NRC Staff Questions Supplemented and Including Alion Testing Facility (VUEZ) Site Visit Comments

(Enclosure 5 to ML080510080 phone call summary of October 31, 2007 and November 29, 2007 phone calls with Alion)

Alion Follow-Up Issues (11/27/07)

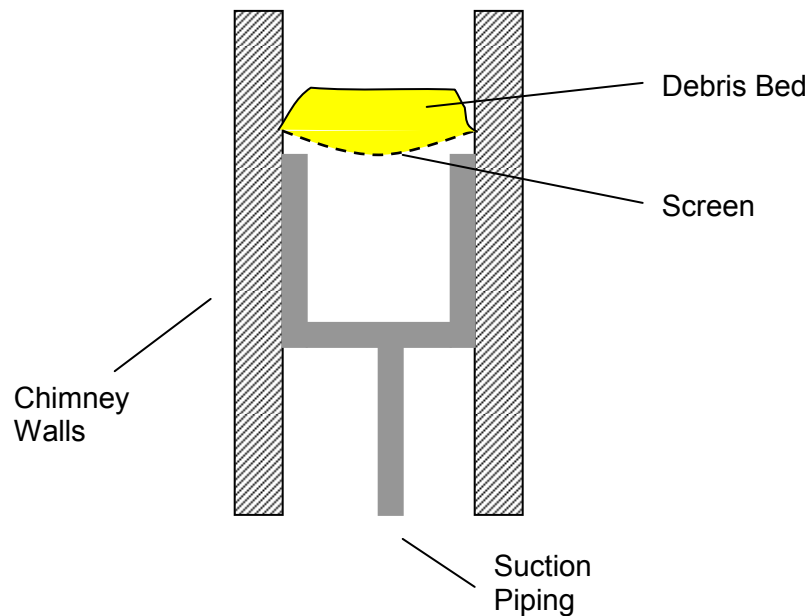
5. Maximum load versus thin bed testing. During the previous call, Alion made the statement that maximum debris cases are chosen for chemical testing based on their causing higher head loss than the thin bed tests during earlier non-chemical testing. Presuming that the bump-up approach is justified, once chemicals are considered, the maximum debris case would continue to be bounding only as long as the thin-bed bump-up factor is not so severe as to overcome the lower thin-bed head loss without chemicals, or

$$\frac{\textit{Thin Bed Bump - up Factor}}{\textit{Maximum Load Bump - up Factor}} \leq \frac{\textit{Maximum Load HL}}{\textit{Thin Bed HL}}$$

Why is there confidence that this must be the case?
